# Access Audit Site Report

**Colorado Bend State Park**  
**1201 Colorado Park Road**  
**Bend, TX 76824**  
**Accessibility Evaluation**  
**Inspection Date: 03/02/2022**  
**Inspectors: Tanya Scheibe**

**TEXAS PARKS AND WILDLIFE DEPARTMENT  
COLORADO BEND STATE PARK**

**AMERICANS WITH DISABILITIES ACT COMPLIANCE INITIATIVE  
PROGRAM AND POLICY REPORT  
JULY 28, 2023**

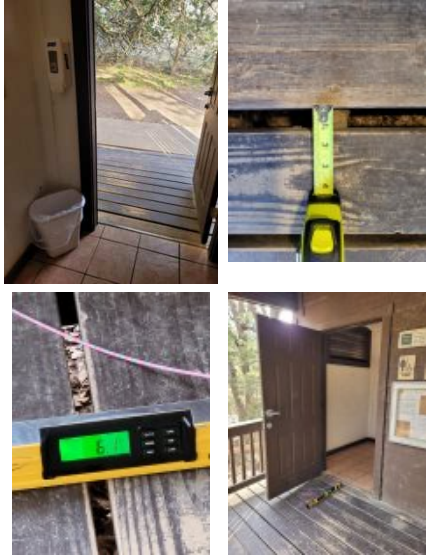
48	1-17 campsites side (Right from HQ) : Men's Restroom 3	[31.0218965 , -98.442808 5]	The side grab bars are not in the correct location. Grab bars on the side wall must be installed so that the end closest to the rear wall is maximum 12" from the rear wall. The end furthest from the rear wall must be mounted minimum 54" from the rear wall.	42" grab bar mounted 5" from rear wall	Remount side grab bar to max 12" from the rear wall at the close end and min 54" on the far end, and 33" to 36" AFF	2015 ABAAS Section: 604.5.1  2012 TAS Section: 604.5.1  2010 ADAS Section: 604.5.1		
49	1-17 campsites side (Right from HQ) : Men's Restroom 3	[31.0218919 , -98.442808 5]	The grab bar height and/or spacing fails. Grab bars must be mounted between 33" and 36" to the top of the gripping surface. There must be 1.5" of clearance between the grab bar and the wall. There must be a minimum of 1.5" of clearance below and minimum 12" above the grab bar to any dispenser or other obstruction.	both 36.5" AFF	Remount grab bars in accessible stall to 33" to 36" above the finished floor (AFF).	2015 ABAAS Section: 609.3, 609.4  2012 TAS Section: 609.4, 609.3  2010 ADAS Section: 609.3, 609.4

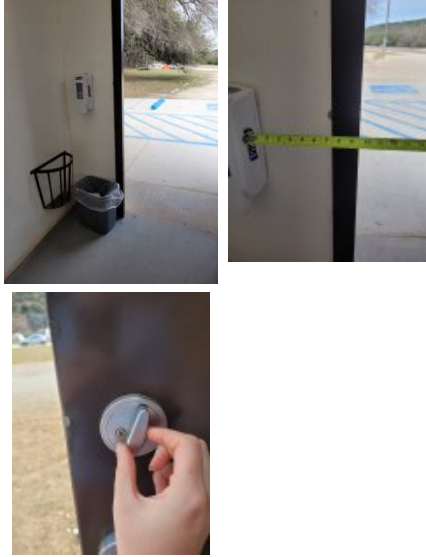
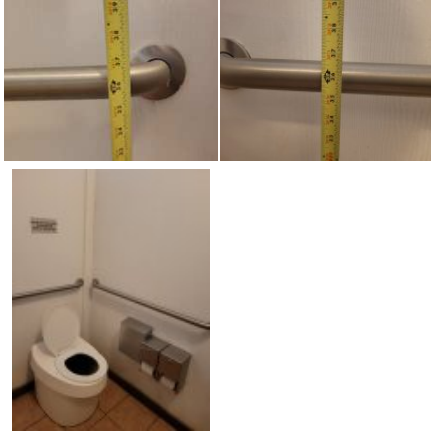
84	18-39 campsites side (Left from HQ): Canyon Group Site	[31.0263406 , -98.441258 2]	Clear ground space 48 inches (1220 mm) by 48 inches (1220 mm) should be provided on all usable sides of the fire ring, grill, fireplace, and woodstove. Center the space on each usable side of the grill, fireplace, and woodstove.	Canyon - lacks accessible surface	Provide required 48" clear ground space centered along usable side of fire ring, grill, fireplace, or woodstove as a smart practice.	2015 ABAAS Section: 1011.2		
85	18-39 campsites side (Left from HQ): Canyon Group Site	[31.026351, -98.441290 4]	Fire building surfaces shall be 9 inches (230 mm) minimum above the ground.	Canyon - fire building surface is ground level	Correct fire building surface to be 9" min above the ground as a smart practice. In the alternative, replace fire ring with a compliant accessible fire ring. In the alternative, leave as is and make other group sites accessible.	2015 ABAAS Section: 1011.5.1

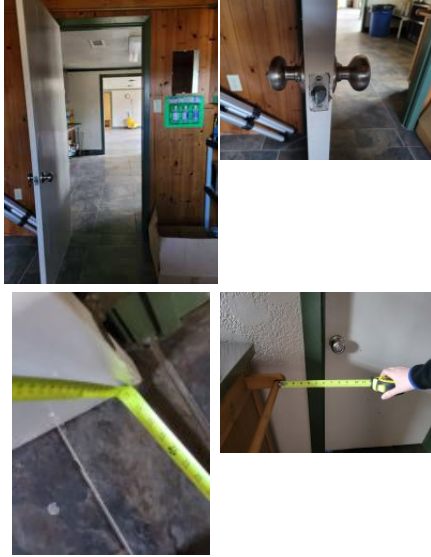
Finding Number	Area Description	Lat/Long	Finding	As Built	Recommendation	Citation	Photos	Figure
98	18-39 campsites side (Left from HQ): Women's Restroom 1	[31.0263878 , -98.4405125]	Minimum maneuvering clearances at doors and gates shall comply with 404.2.4. Maneuvering clearances shall extend the full width of the doorway and the required latch side or hinge side clearance. Maneuvering clearances shall have a max slope of 2.08%. The threshold has a vertical change greater than 1/4 inch high.	Door - hand sanitizer and trash in clearance on push, 1" CIL	For all doors along the public circulation route, provide required maneuvering clearance on push and pull side of doors. For all doors along the public circulation route, repair, bevel, or ramp CILs at door entries to max .25".	2010 ADAS Section: 404.2.3, 404.2.7, 404.2.4, 404.2.11, 404.2.11 Exception

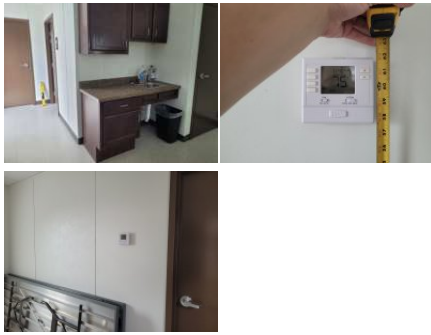
Finding Number	Area Description	Lat/Long	Finding	As Built	Recommendation	Citation	Photos	Figure
110	Gorman Falls/ Conference Center : Conference Center	[31.05715, -98.481818 5]	Spaces and elements within employee work areas shall only be required to comply with 206.2.8, 207.1, and 215.3 and shall be designed and constructed so that individuals with disabilities can approach, enter, and exit the employee work area. Employee work areas, or portions of employee work areas, other than raised courtroom stations, that are less than 300 square feet (28 m2) and elevated 7 inches (180 mm) or more above the finish floor or ground where the elevation is essential to the function of the space shall not be required to comply with these requirements or to be on an accessible route.	Storage door - knob	For employee spaces, relocate storage, furniture, and other obstacles at doorways to provide approach, enter and exit at the employee space. Replace hardware with lever hardware or hardware operable without a tight pinch or grasp.	2015 ABAAS Section: F203.9 2012 TAS Section: 203.9 2010 ADAS Section: 203.9

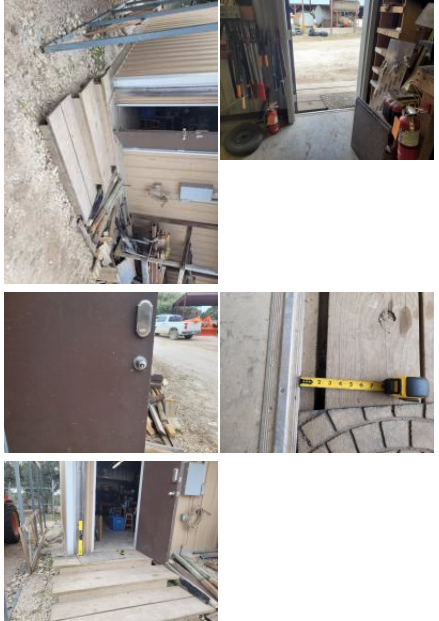
Finding Number	Area Description	Lat/Long	Finding	As Built	Recommendation	Citation	Photos	Figure
117	Maintenance/ Police : Maintenance/ Police - Parking	[31.0518904 , -98.500744 2]	Element meets all standards and requirements	police parking - 1 accessible stall, estimated 10 standard stalls. Scoping requirements comply	None	2010 ADAS Section: N/A		
118	Maintenance/ Police : Maintenance/ Police - Parking	[31.0519329 , -98.500791 1]	The access aisle is not a minimum 5 feet wide. A car accessible parking stall's access aisle must be a minimum of 5 feet wide measured from centerline to centerline. Where the access aisle is not adjacent to another parking space or access aisle, measurements shall be permitted to include the full width of the line defining the access aisle.	police parking - 56" width access aisle, space provided, just needs repainted	Repaint access aisles to be 5' each	2015 ABAAS Section: 502.3.1  2012 TAS Section: 502.3.1  2010 ADAS Section: 502.3.1
